# Public Works (1899) Department.

G.O., No. 965 W

Quarters for inferior Servants at Allahabad

With reference to your Memorandum No 4,843 C dated 4th November 1898, I have the honor to forward for early sanction plans and estimates amounting to Rs 17,700 for the additions and alterations to the Government Secretariat offices main and detached buildings on Stone house hill at Ootacamund.

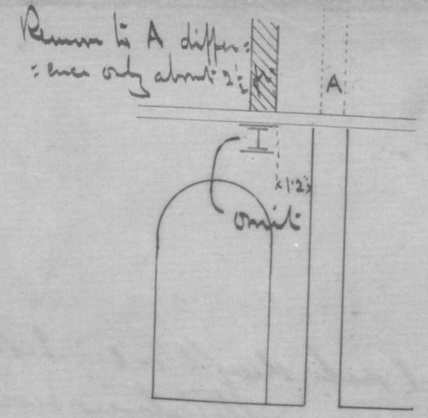
floor and the girder above among with the weight that the enformed girder has to carry is calculated at 47 Tons against 38 Tons as per E E's calculations, vide pencil alterations on the calculation sheet attached to the estimates. The difference in weight is due to the omission of the upper terrace and the live load on the first floor. The section proposed viz $21\frac{1}{2}$"x12" weighing 144 lbs with the two weak in section $21\frac{1}{2}$"x18" weighing 260 lbs would be required vide Govt. Insp. Engs. section page 94. This will increase the estimate by £500.

The section of the transmission carrying the masonry wall, viz, 5½"x8" is weak and may be increased to 10"x6".

The area of the existing P.W.D. clerks room on the basement floor is (16'0"x27'8") 442 sq ft and C de W's room (16'0"x10'6") 168 sq ft or a total area of 610 sq ft. It is proposed to locate this office in the upper floor by building a hall measuring 44'0"x31'6" having a floor area of 1386 sq ft. this area is almost twice the existing accommodation on the lower floor & as Govt has no room for himself it is submitted that Govt's existing room, marked A A on upper floor plan may be retained without having the northern wall removed the remaining portion of the wall, as shown on the alternative plan, now submitted be allotted to the P.W.D clerks. This will still give a larger area than their existing room on the ground floor, viz from 442 sq ft to (28½x31) 883½ sq ft.

Yes

Yes
